BID Addendum-01

Project No.
JCDT23-0185

Title
Bid Clarification 01

Project Name
St Clair County Heath Dept Relocation

1 LEVEL 1 LIGHTING - SHEET
 E20-01 SCALE: 1/8" = 1'-0"

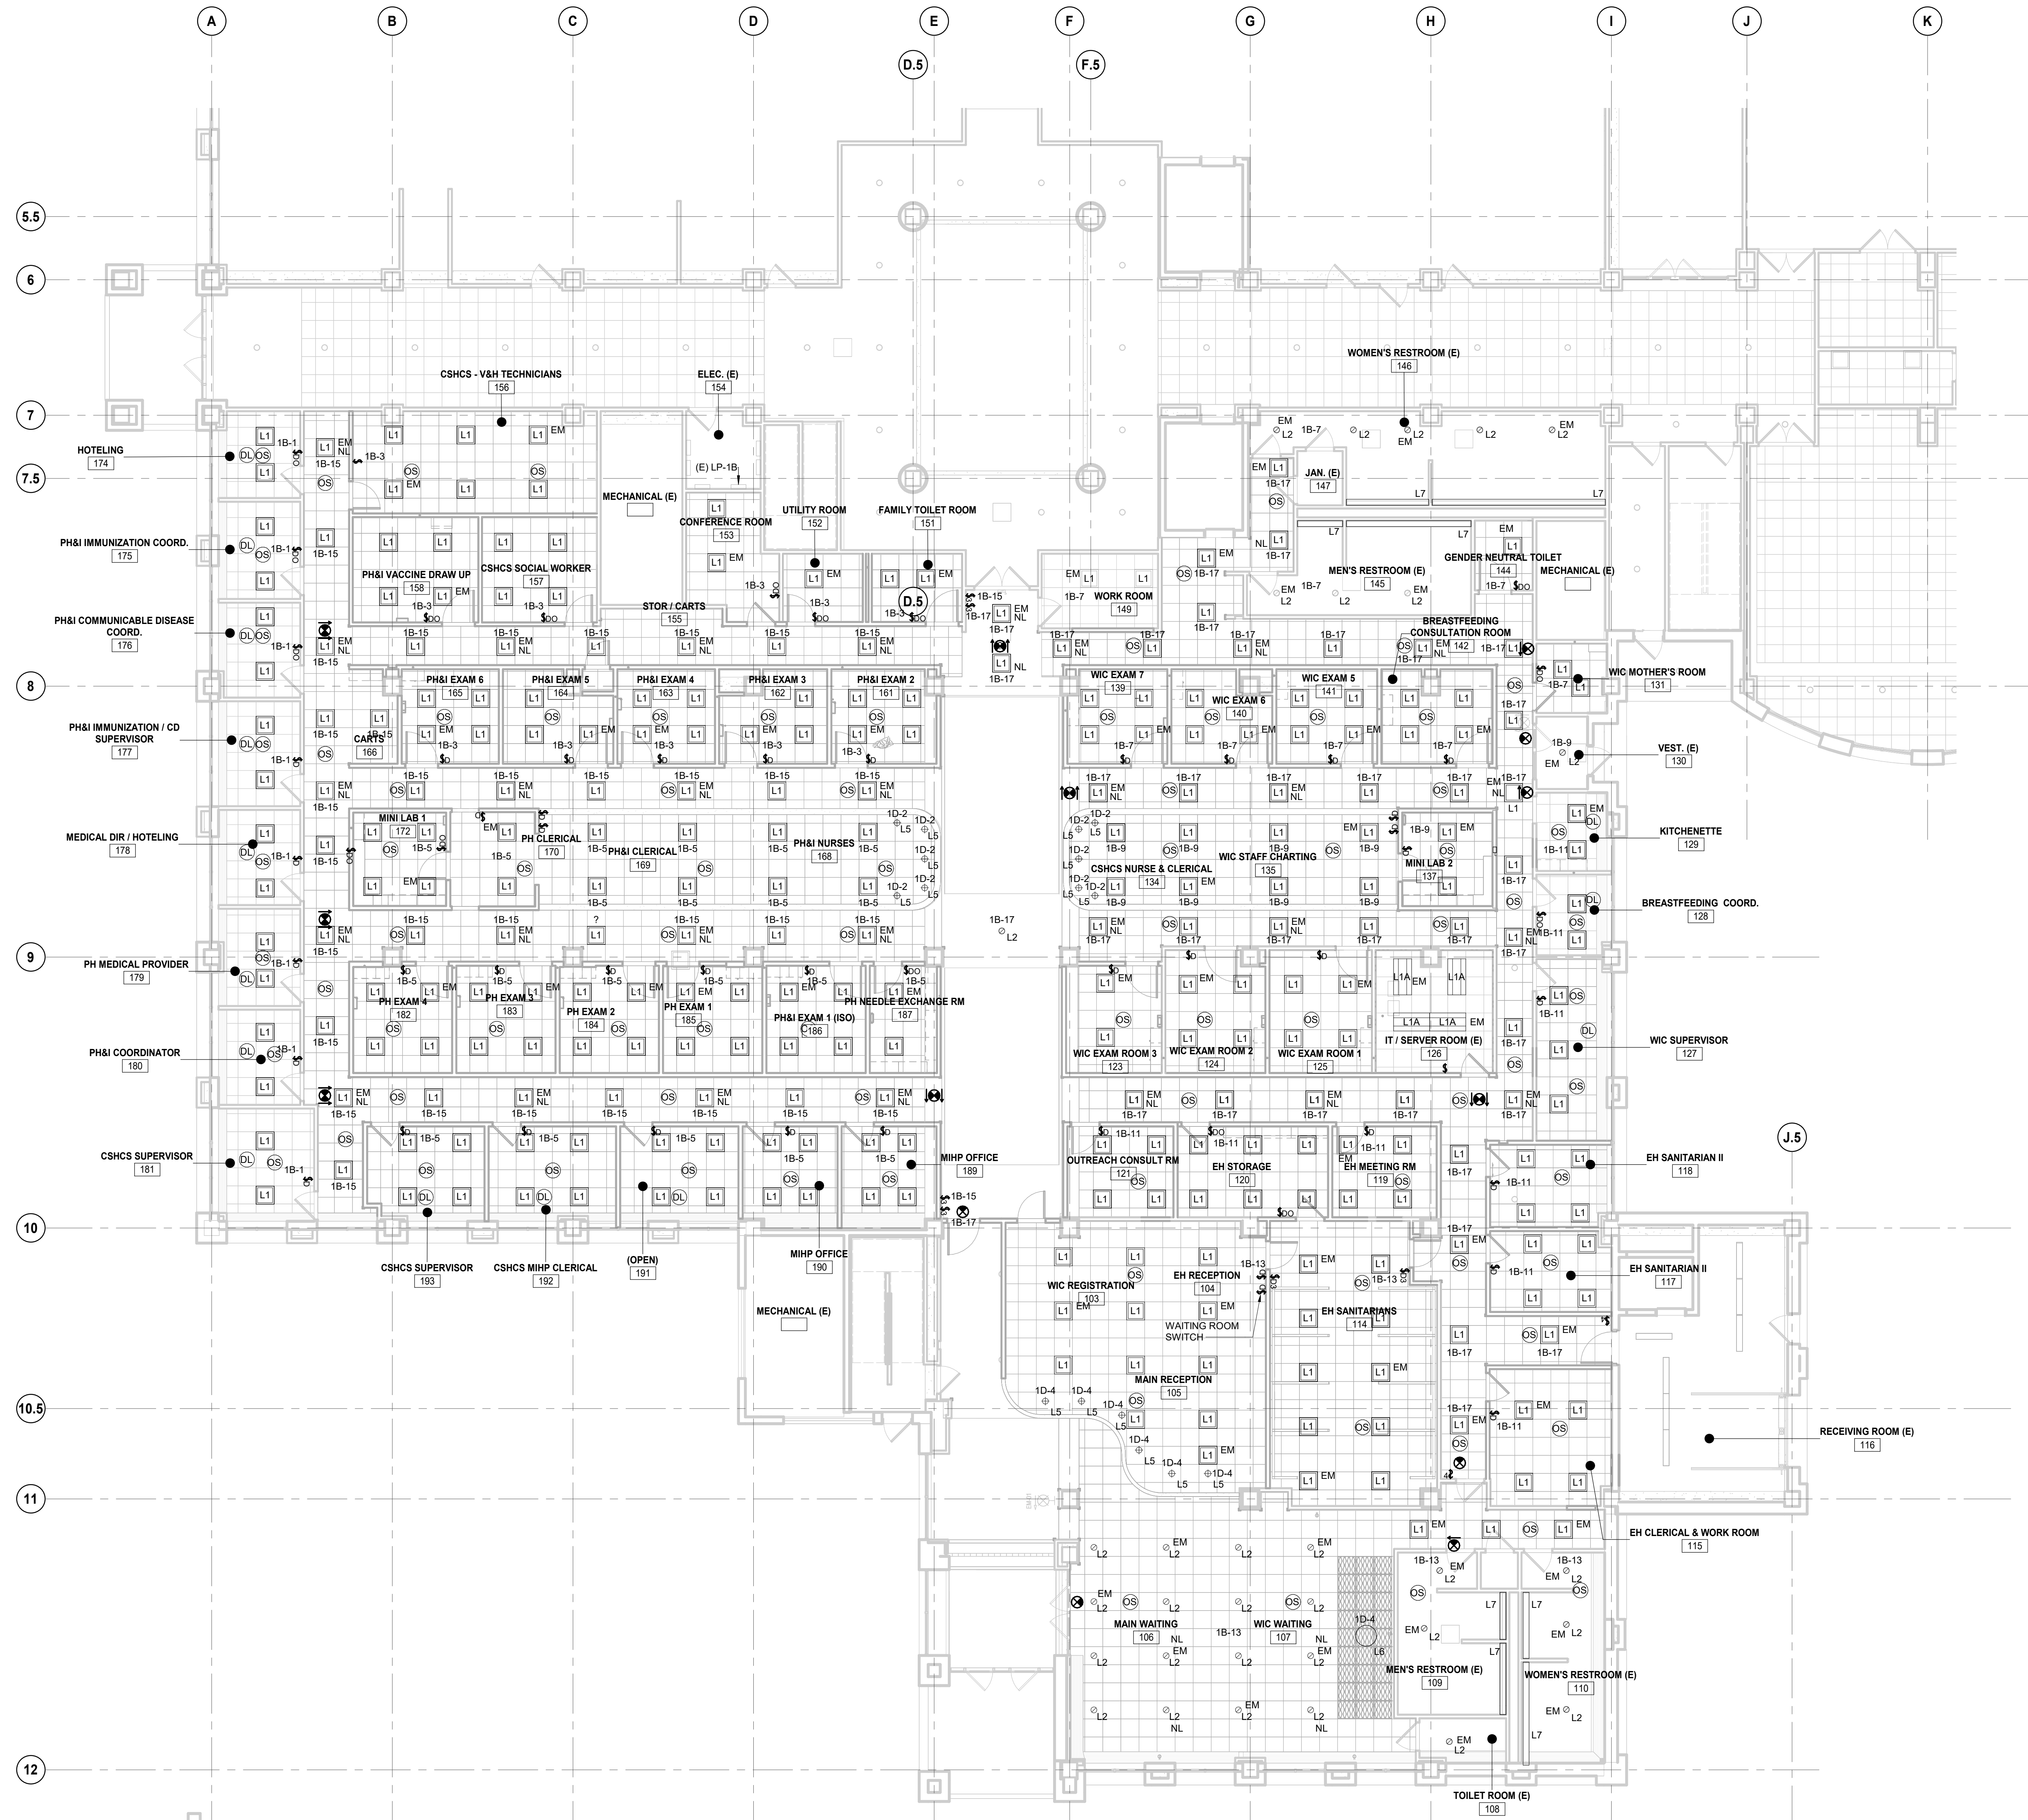
- a. Added circuiting for new roof mechanical equipment.
6. Sheet E20-01 – SOUTH WING – LEVEL 1 LIGHTING PLAN
 - a. Added circuiting for lighting.
 - b. Added emergency fixtures where required.

- c. Added sensors and switches to areas where they weren't shown.
 - d. Added/revised exit signage layout.
7. Sheet E20-02 – SOUTH WING – LEVEL 2 LIGHTING PLAN

1 LEVEL 2 LIGHTING - SHEET
 E20-02 SCALE: 1/8" = 1'-0"

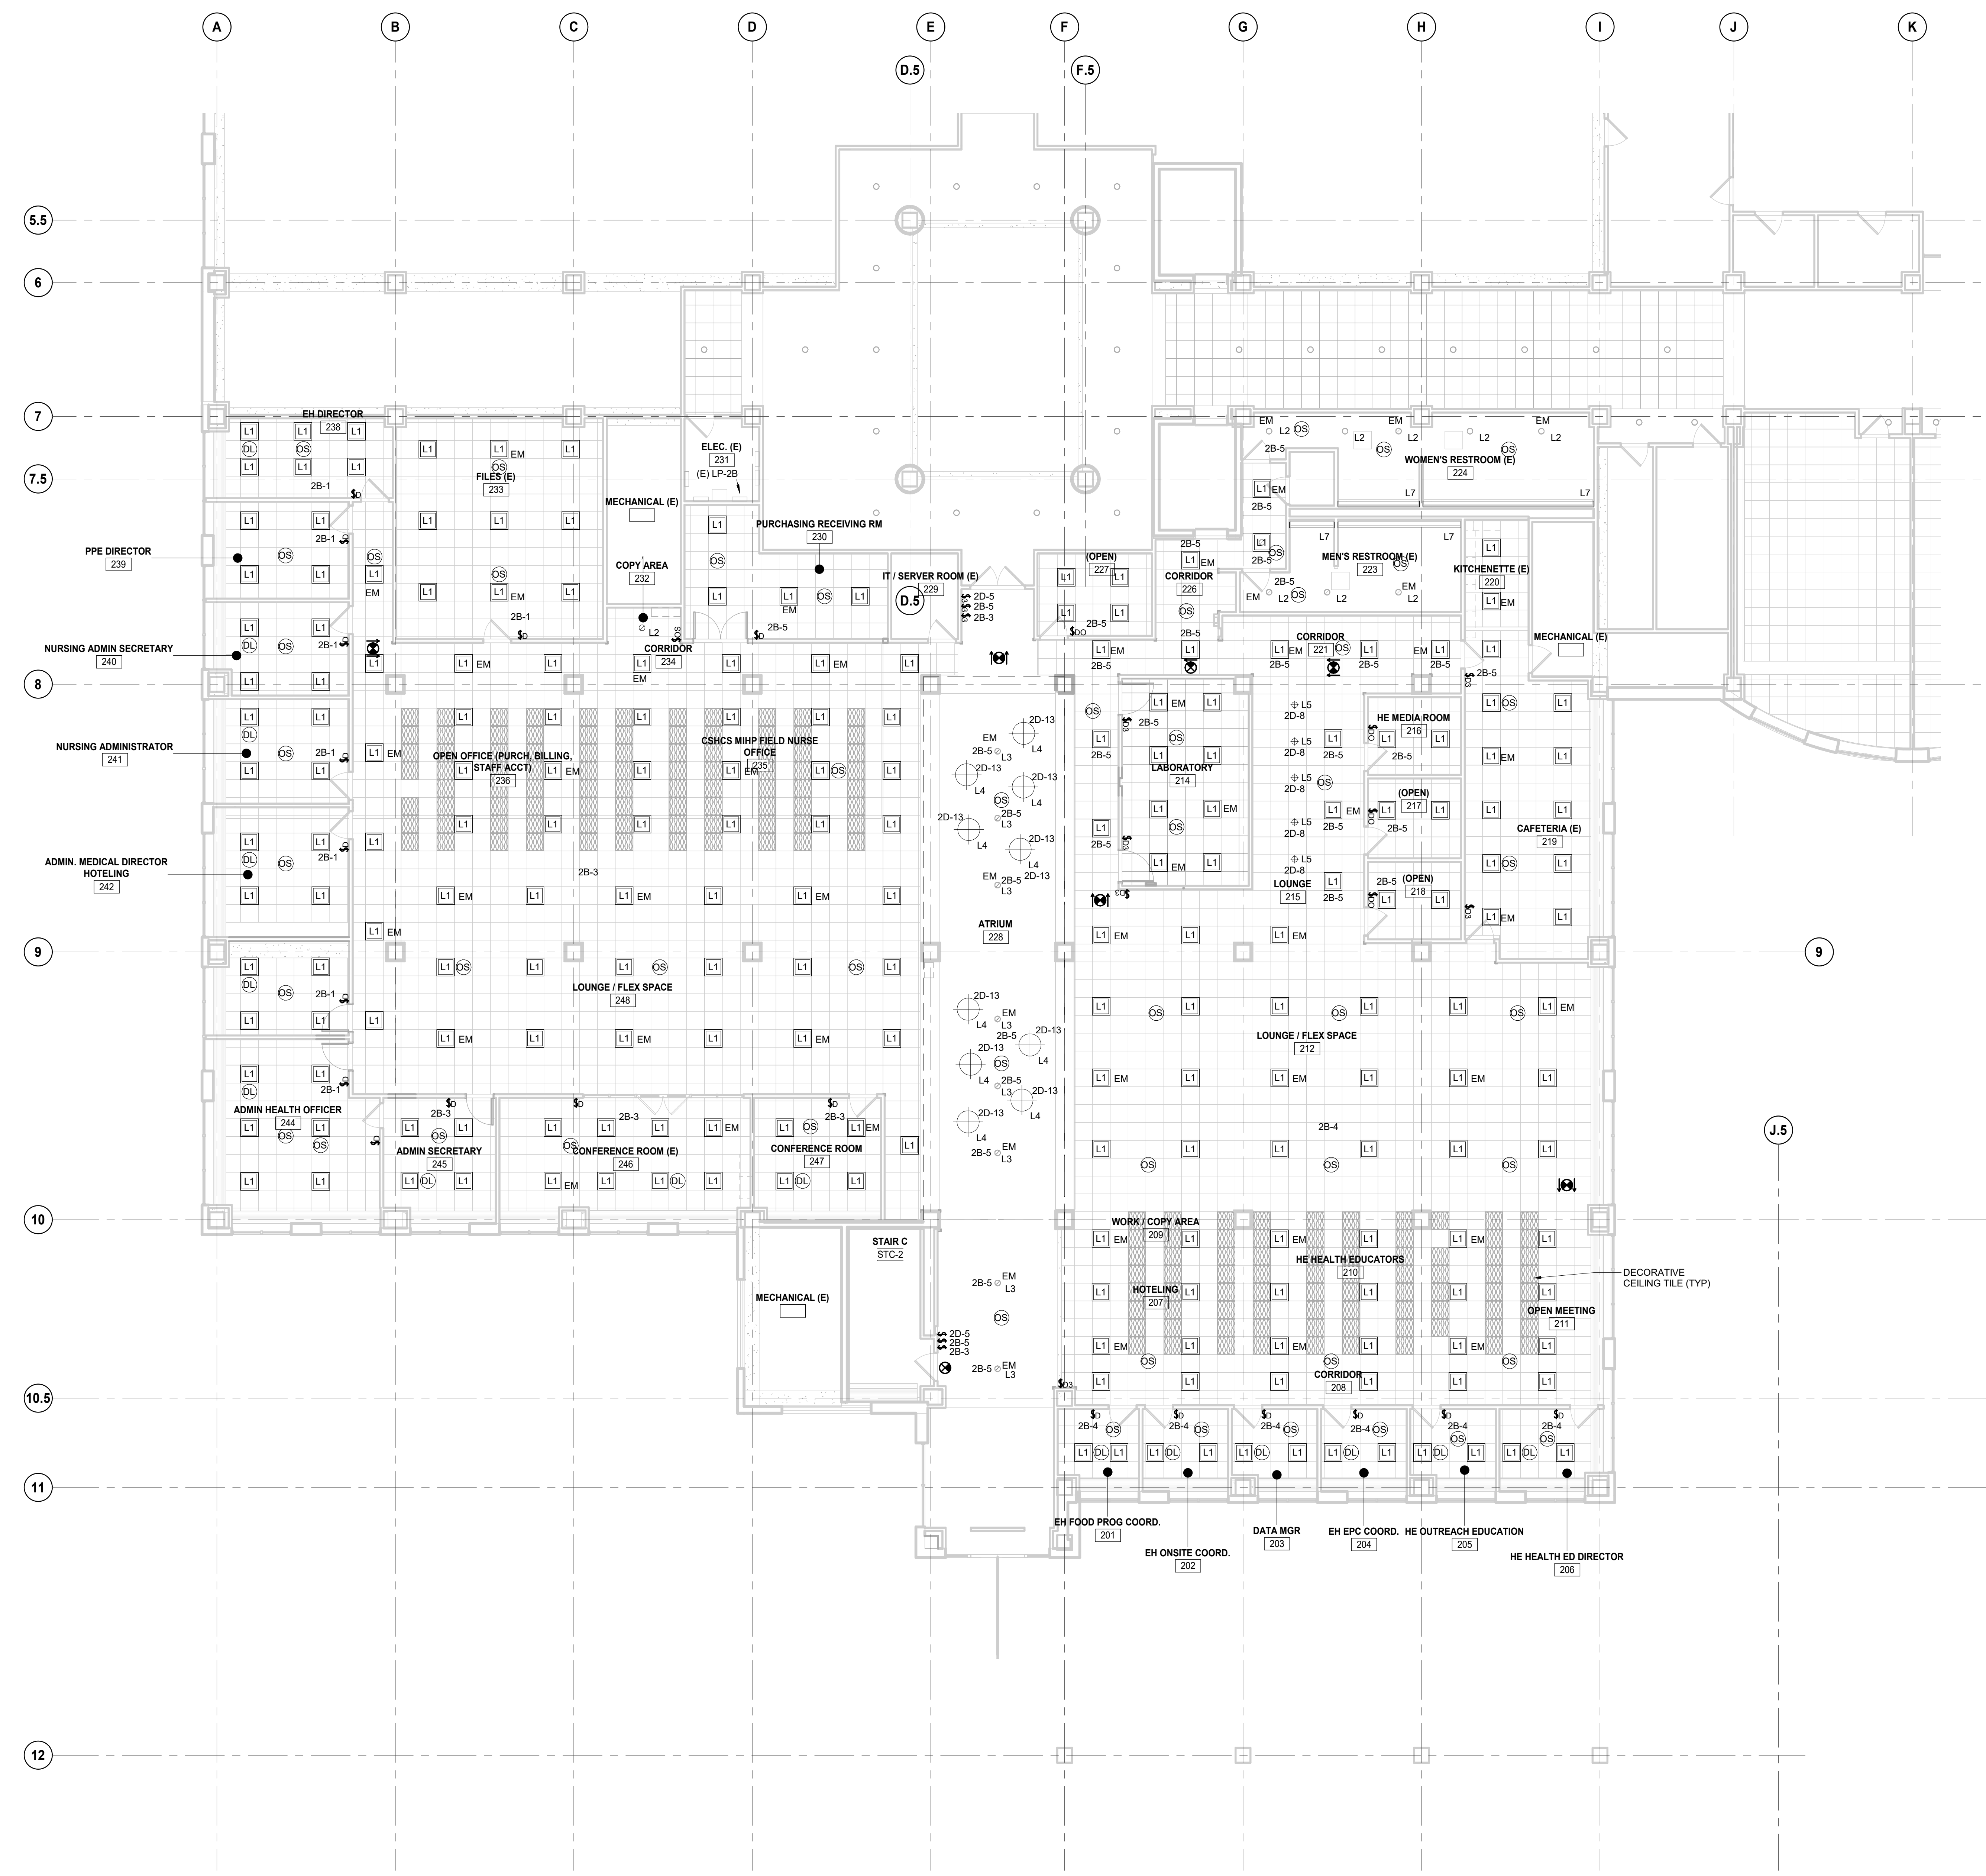
- a. Added circuiting for lighting.
 - b. Added emergency fixtures where required.
 - c. Added sensors and switches to areas where they weren't shown.
 - d. Added/revised exit signage layout.
